NUCLEAR REGULATORY COMMISSION

Title: Advisory Committee on Reactor Safeguards
Regulatory Policies and Practices

Date: Thursday, August 18, 2011

The Subcommittee will hear presentations from the NRC Staff regarding the new Staff Guidance for use in selecting the design basis hurricane wind speed and hurricane generated missiles that a new nuclear power plant should be designed to withstand, as discussed in the draft Reg Guide 1.221, Design Basis Hurricane and Hurricane Missiles for Nuclear Power Plants.

Holland B Parameter

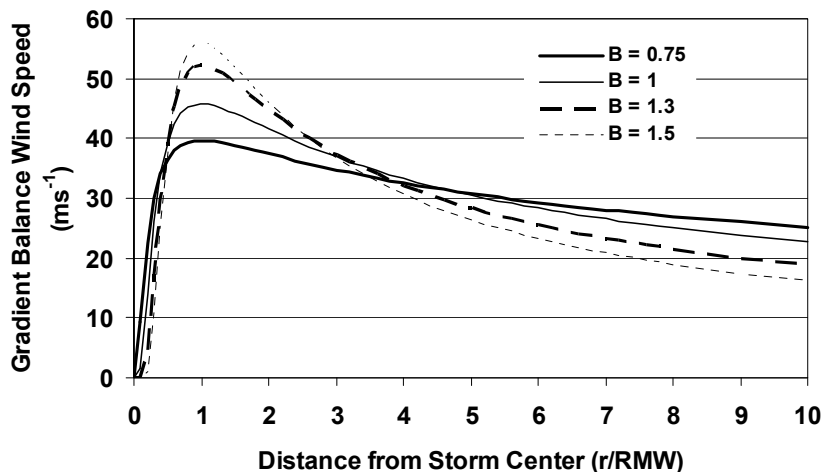
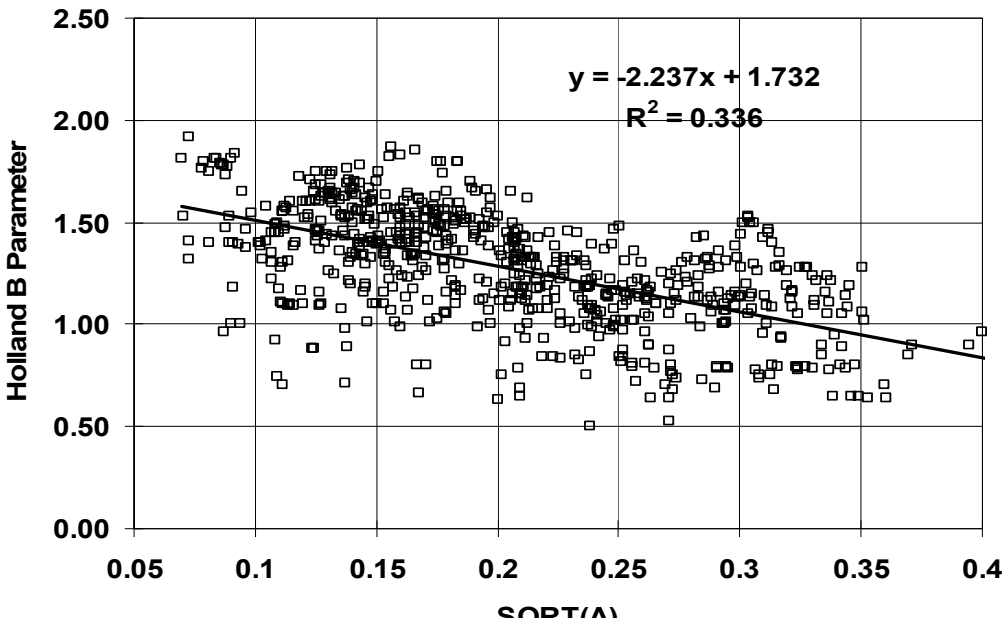
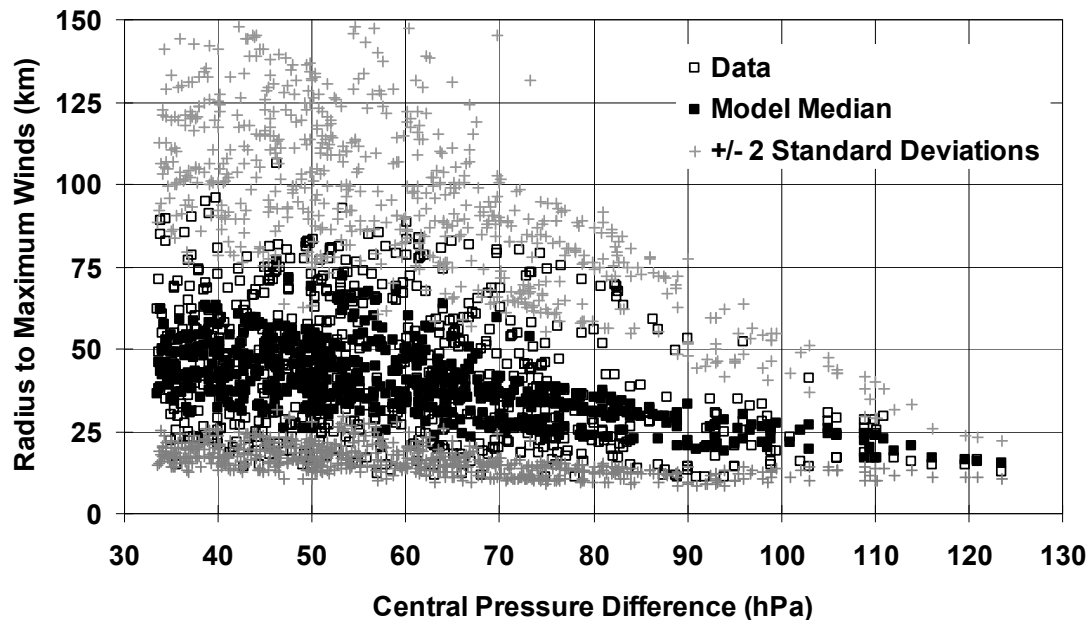
10 CHAIR SHACK: The Figure 2-7 in the NUREG
11 seems to have a different database for the B parameter
12 than you're showing here.

14 CHAIR SHACK: Yes, it's Figure 2-7. It's
15 referring back to the 2009 paper.

9 CHAIR SHACK: Well you need to put this
10 figure in.

13 CHAIR SHACK: I mean this figure looks
14 like what I'd expect to see in a regression fit.

Peak Gust Wind Speed (10m, Marine) at Landfall from 10^7 Year Simulation

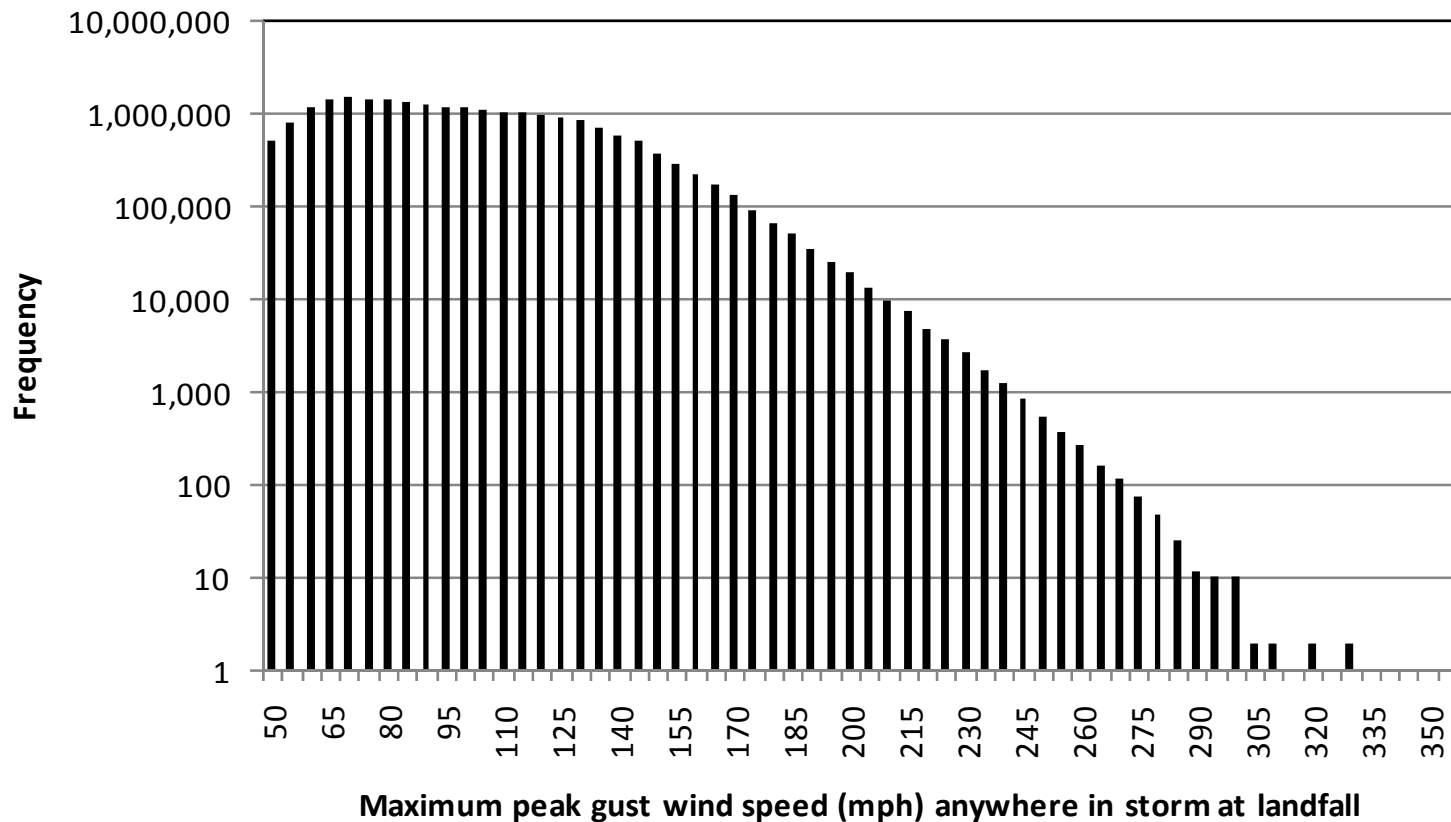
18 MEMBER STETKAR: How would the behavior of
19 that tail, and if I back up sort of a quarter of the
20 way into that distribution change, instead of using
21 what you're calling a nominal 10^{-7} year simulation,
22 instead of having 23 million samples, I had 230
23 million samples for 2,300 million samples.

1 what you're calling more years, how would the behavior
2 of that tail change?

9 MEMBER STETKAR: The question I have then
10 is, how sensitive is the shape of that distribution
11 out in that tail, to your sampling algorithms and the
12 number of samples you're taking and, you know, you're
13 limited by your data set.

14 I step back to regulatory decisions that
15 are being based on the assertion that we have
16 confidence that a change of 15 percent in peak gust
17 wind speed results in a reduction of a factor of 1,000
18 in frequency, because people are making decisions on
19 the same level.

14 MR. VICKERY: Yes. It's a good question
15 that I don't know the answer to it.
